February 5, 2019
L-18-242

Davis-Besse Nuclear Power Station, Unit No. 1
Docket No. 50-346, License No. NPF-3
License Amendment Request – Proposed License and Associated Technical Specification
Changes for Permanently Defueled Condition

Figure 3.7.16-1 (page 1 of 1)
 Burnup versus Enrichment Curve for
 Spent Fuel Pool Storage Racks

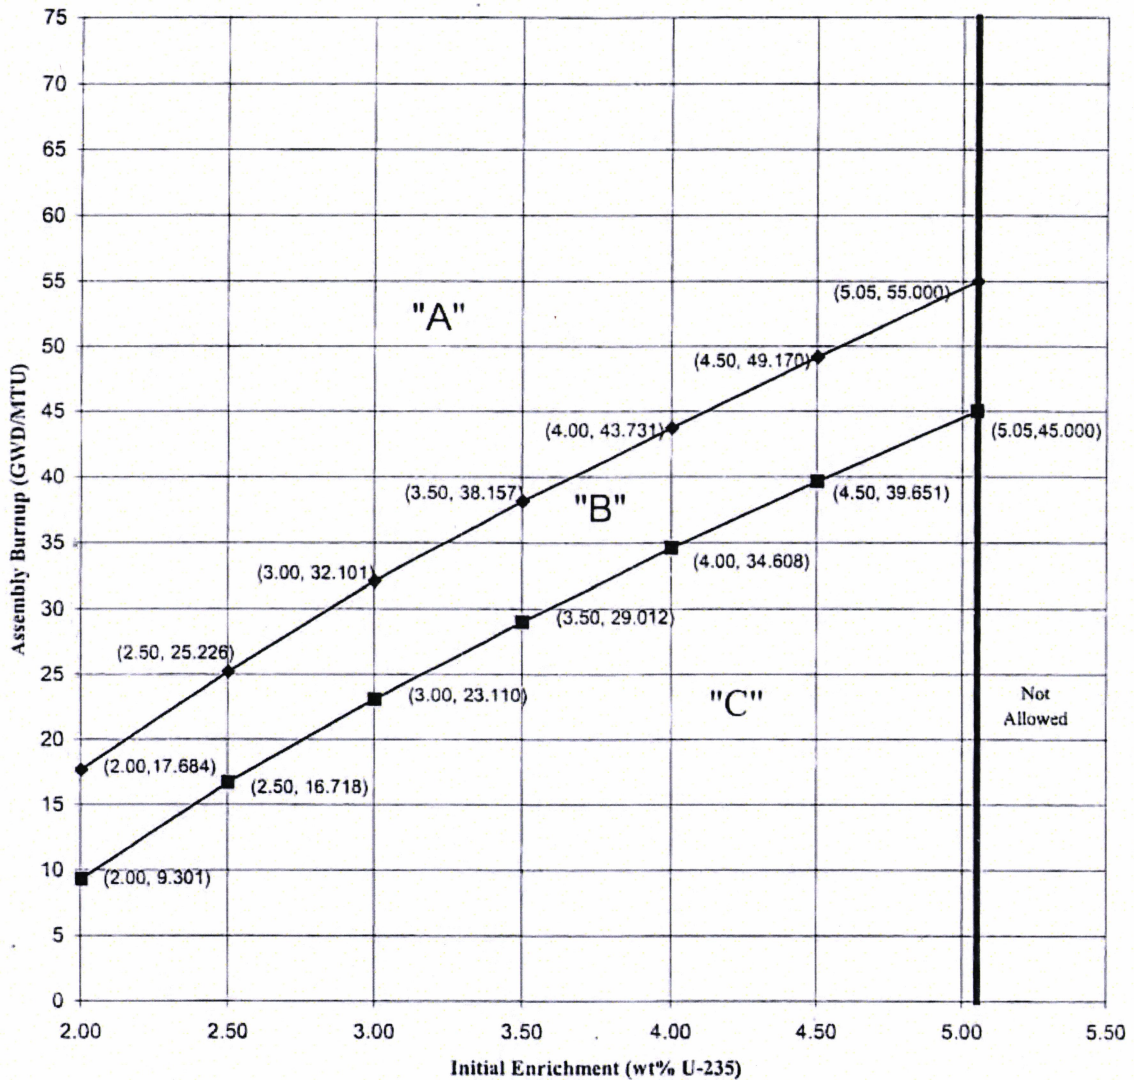
MZTR is a loading pattern where ~~fresh or~~ low burnup assemblies (identified as Region 1 assemblies) are separated from each other and from intermediate burnup fuel assemblies (identified as Region 3 assemblies) by barrier fuel assemblies with high burnup (identified as Region 2 assemblies). CB is a loading pattern of empty cells, or cells with non-fuel bearing components, and cells with ~~fresh or~~ low burnup assemblies (Region 1). HL is a loading pattern of intermediate burnup fuel assemblies (Region 3). Region 2 assemblies correspond to Category A in Figure 3.7.16-1, Region 3 assemblies correspond to Category B in Figure 3.7.16-1, and Region 1 assemblies correspond to Category C in Figure 3.7.16-1. ← New fuel is no longer stored onsite.
